Safety Evaluation Report

related to renewal of the
operating license for the
Texas A&M University Research Reactor

Docket No. 50-128
License R-83

March 1983

Figure 17.1 FLIP fuel element spacing in the Texas A&M reactor core near transient rod

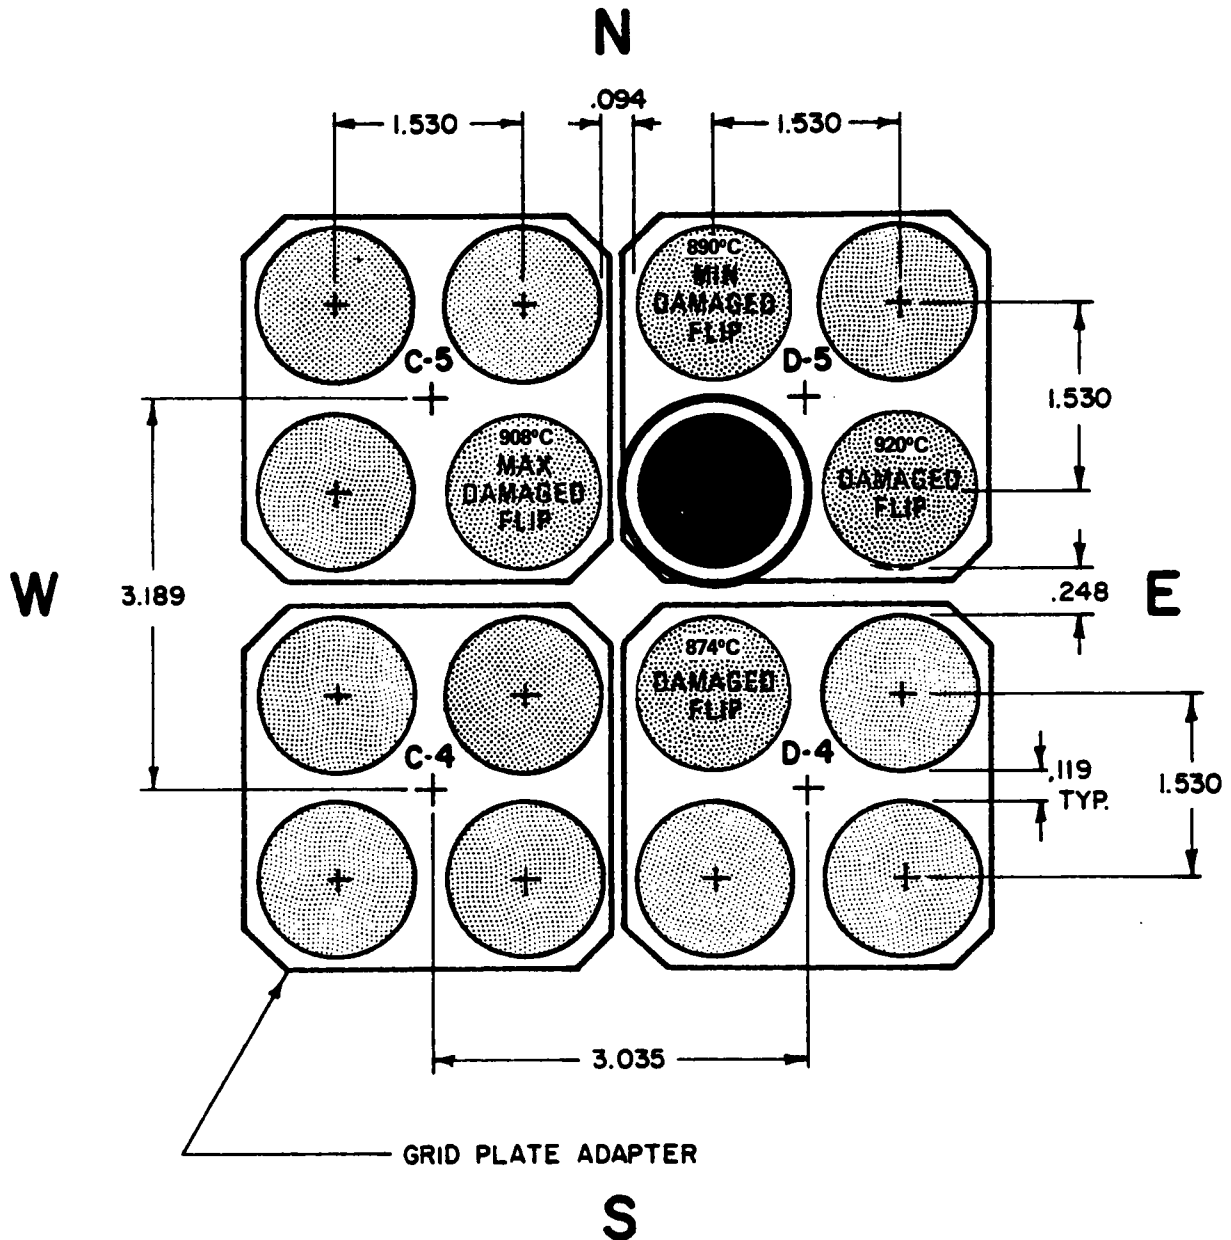
During a loading operation on September 27, 1976, three* damaged fuel elements were discovered in the core. Fuel element deformation but no cladding failure were noted (see Figure 17.1). A report on the discovery and preliminary analysis was submitted from the applicant to the staff on November 1, 1976. At that time it was determined that no valid conclusion concerning the cause of the damage was possible without metallographic examination of the damaged fuel elements. Argonne National Laboratory (ANL-West) had TRIGA-FLIP fuel and the necessary analytical facilities to perform these examinations. Because of delays as a result of hot cell modifications, the low priority of this project, and coordination of personnel from Texas A&M, Argonne National Laboratory, and General Atomics Company, it was several years before data were collected and the evaluation of the work completed. The final report was issued in December 1981 (GA-A16613) with the proposed damage mechanism receiving consensus from those concerned.

- (1) During continuous operation for long periods, there is hydrogen migration radially and axially from regions of higher temperatures to regions of lower temperatures. This produces local areas of high concentrations of hydrogen, which could be sources of high pressure at higher temperatures experienced mostly during long-term operations (see Figure 17.1).

Figure 17.2 Zirconium-hydride phase diagram showing boundary determination

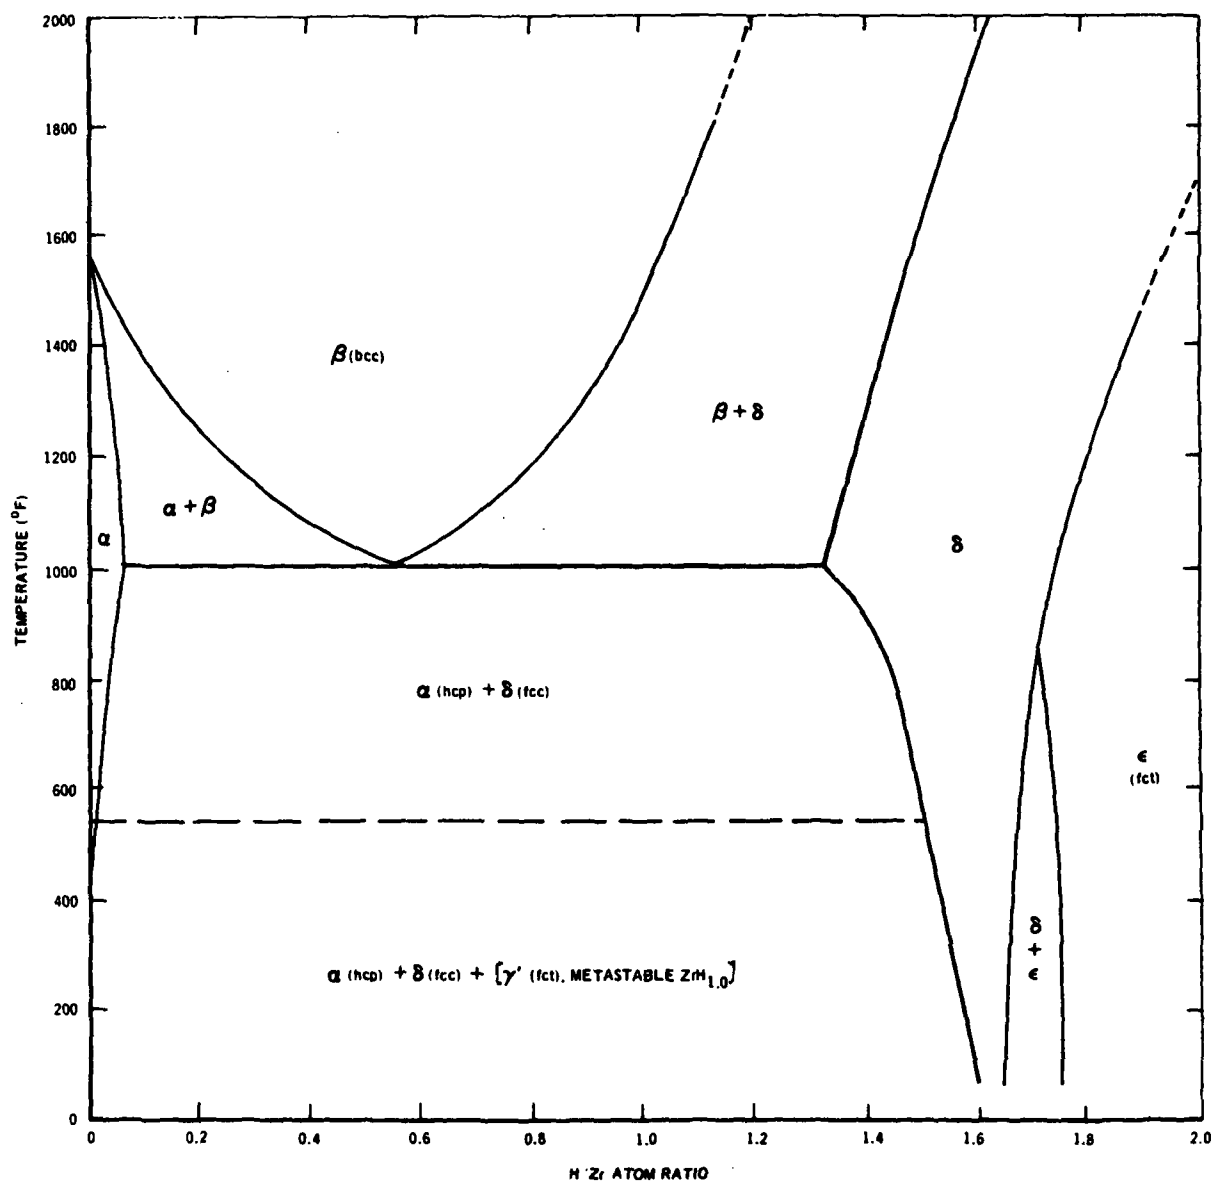
The damaged fuel elements were FLIP fuel, fabricated with a hydrogen-to-zirconium ratio of 1.6. This hydrogen-to-zirconium value was carefully selected to take advantage of several properties of zirconium hydride. Figure 17.2 reproduces a phase diagram of ZrH_x presented by Simnad (GA-4314, 1980). The diagram indicates that a hydrogen-to-zirconium atom ratio of 1.6 produces the delta phase and remains in this phase to well over 1,000°C. This avoids substantial volume changes resulting from phase transformations that occur at approximately 530°C at lower hydrogen ratios (GA-9064, 1970 and GA-6874, 1966). It also produces a material that exhibits very small density changes with varying hydrogen content (GA-4314, 1980). An additional advantage of the delta phase is that it has much greater creep strength than the beta phase. However, if the fuel is used
